ADDENDUM No. 5

Description of Bid #5952 Spring Canyon Community Park

DESCRIPTION: Addenda #5 (BASEBALL FENCING)

DRAWING NUMBER:
 D23-A5

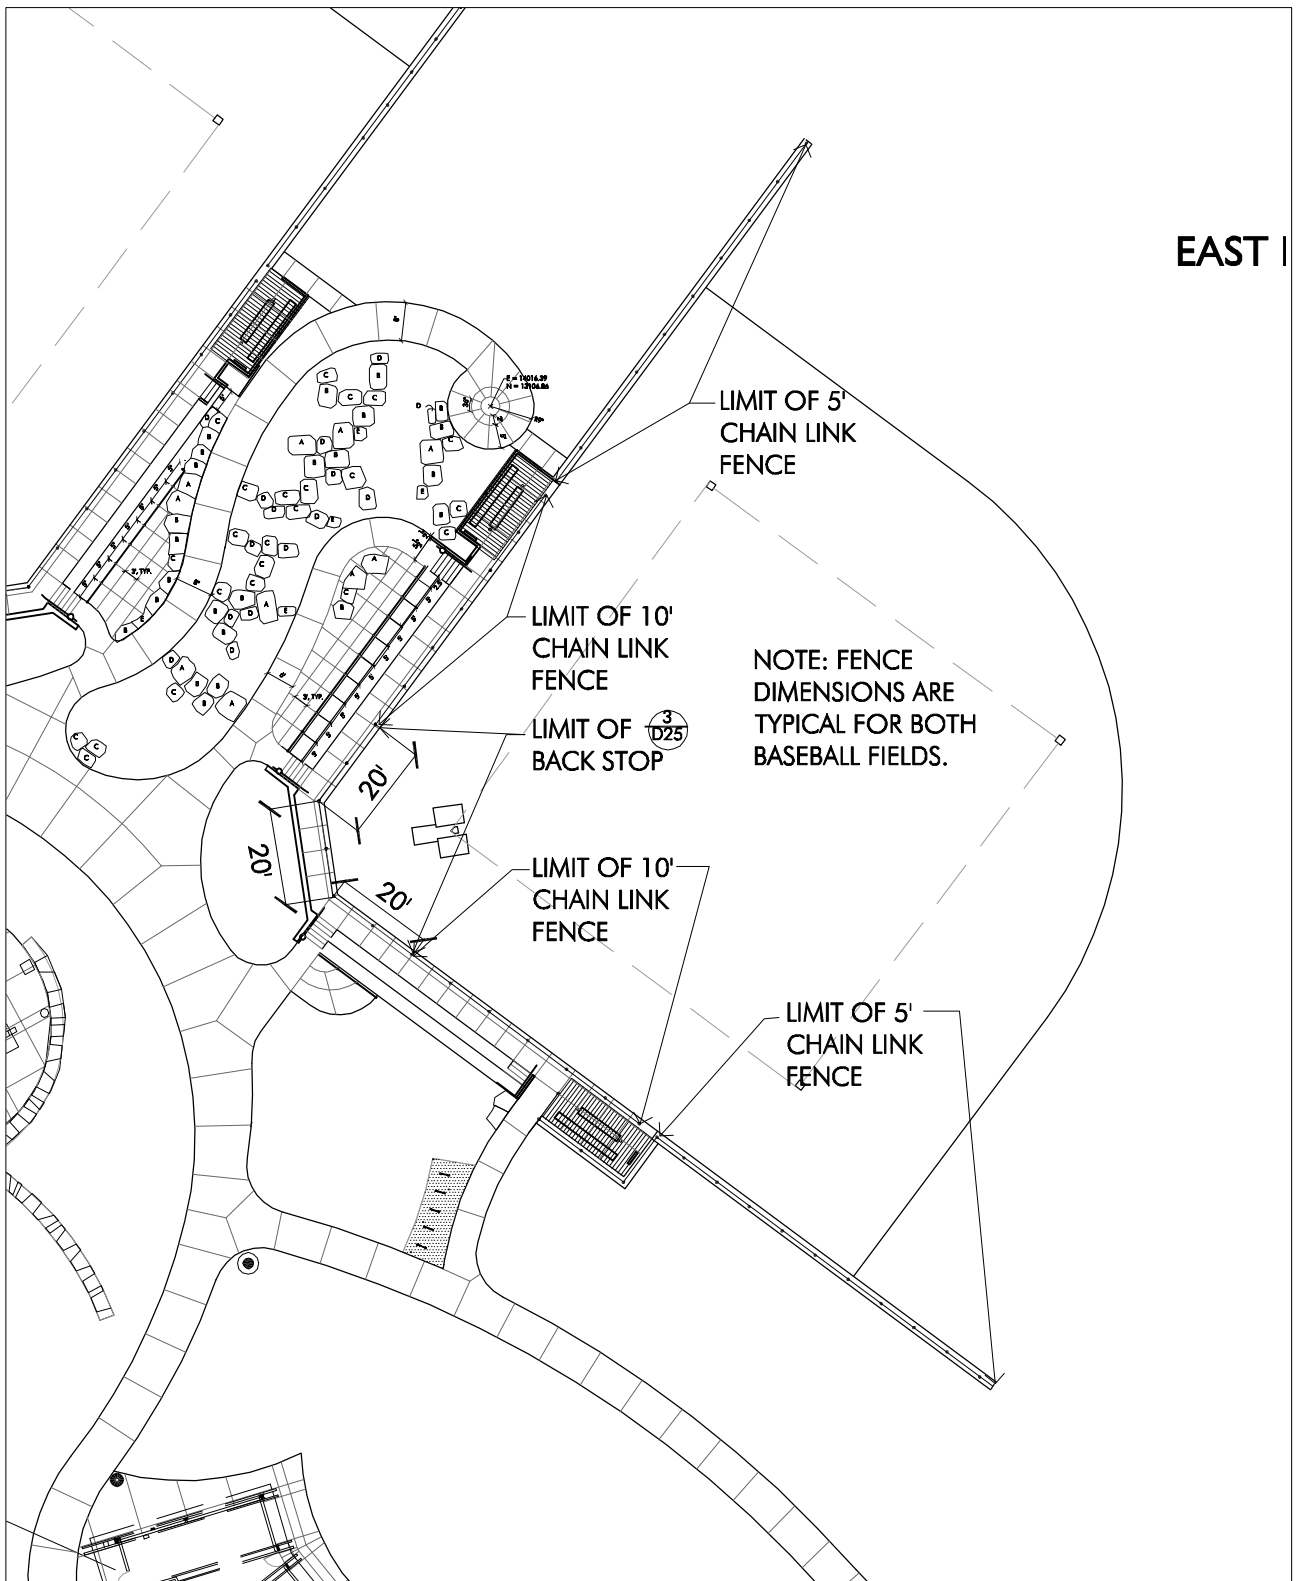
1. The fence behind the dugout shall be 5'-6' high; Refer to sheet 22 and details 2 and 4 sheet D25
2. The card reader hardware on sheet S5 shall be provided and installed by owner. Conduit shall be provided per sheet E6

Drawing D23-A5: Base Ball Fence Layout
Drawing S10-A5: Dog Park Clarifications
